ALABAMA WEST SUBDIVISION, UNIT THREE

APPLICATION NUMBER 6 DATE August 16, 2007

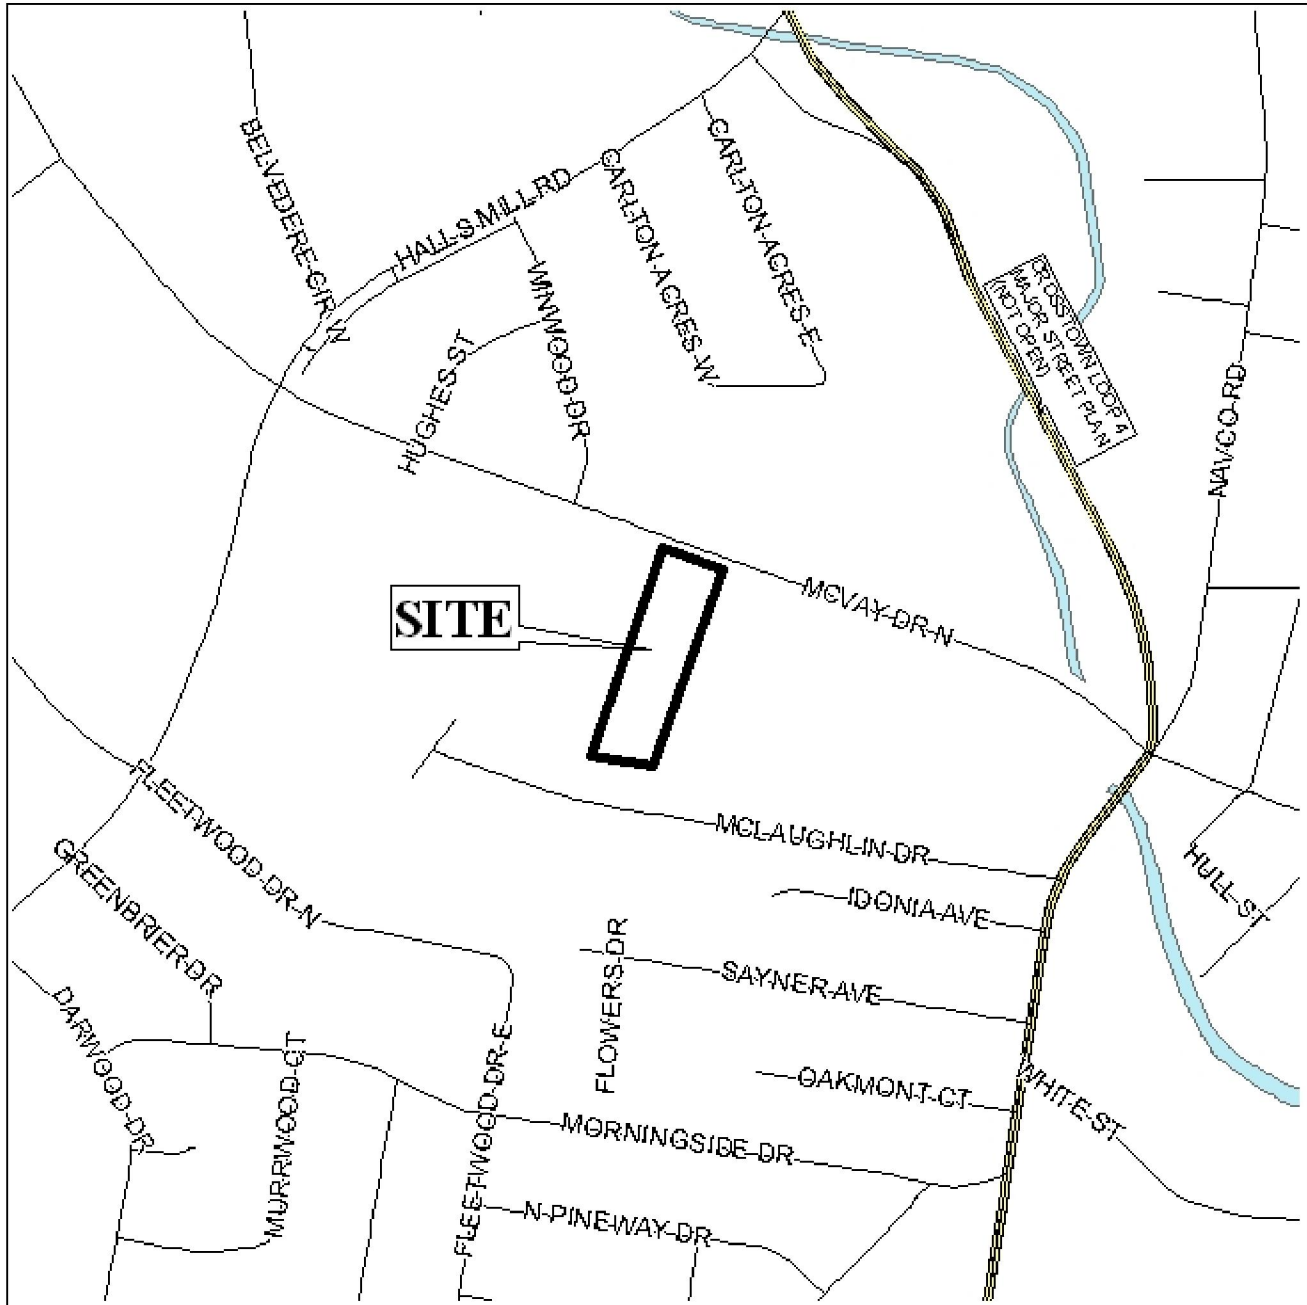
The final plat should indicate a minimum building setback line of 25' or greater. A 40' minimum building setback line is indicated along McVay Drive, similar to that recorded on Lots 7 and 8.

The proposed lot is bordered on the Southeast portion by the area indicated as the detention pond in the original Alabama West Subdivision approval. A condition of the original approval was the depiction of an access easement or dedicated access to the detention pond. Since Lot 9 will be the first portion of the originally-approved subdivision to border the proposed detention pond area, this condition should be applied to Lot 9. And since the original subdivision was approved subject to the placement of a note on the final plat stating that maintenance of the detention common areas, and any other common areas, are the responsibility of the property owners, this note should also be placed on the Lot 9 plat.

To the East of the site is the Bolton Branch of Dog River, and wetlands associated with the water body may be present on the site. The possible presence of wetlands indicates that the area may be environmentally sensitive; therefore, the approval of all applicable federal, state and local agencies would be required prior to the issuance of any permits or land disturbance activities. A note should be placed on the final plat stating that if wetlands are present, the approval of all applicable federal, state, and local agencies would be required regarding the wetlands and floodplain issues prior to the issuance of any permits.

Based on the preceding, the plat meets the requirements of the Subdivision Regulations and is recommended for Tentative Approval, subject to the following conditions:

- 1) the placement of a note on the final plat stating that Lot 9 is limited to one shared curb cut with Lot 8, with the size, location, and design to be approved by Traffic Engineering and conform to AASHTO standards;*
- 2) depiction of the shared curb cut with previously recorded Lot 8 along McVay Drive at the Northwest corner of Lot 9;*

- 3) *depiction of an access easement or dedicated access to the proposed detention pond area along the Southeast portion of the property;*
- 4) *placement of a note on the final plat stating that the maintenance of the detention common areas, and any other common areas, are the responsibility of the property owners*

- 5) *placement of a note on the final plat stating that if wetlands are present on the site, the approval of all applicable federal, state, and local agencies would be required regarding the wetlands and floodplain issues prior to the issuance of any permit; and*

- 6) *subject to the Engineering Comments (All storm water shall be captured on-site; if water is concentrated onto an adjacent property owner, a release agreement is required. No fill in AE flood plain without a flood study. No detention allowed in the AE flood plain. It is the responsibility of the applicant to look up the site in the City of Mobile (COM) GIS system and verify if NWI wetlands are depicted on the site. If the COM GIS shows wetlands on the site, it is the responsibility of the applicant to confirm or deny the existence of wetlands on-site. If wetlands are present, they should be depicted on plans and/or plat, and no work/disturbance can be performed without a permit from the Corps of Engineers. Must comply with all storm water and flood control ordinances. Any work performed in the right of way will require a right of way permit).*
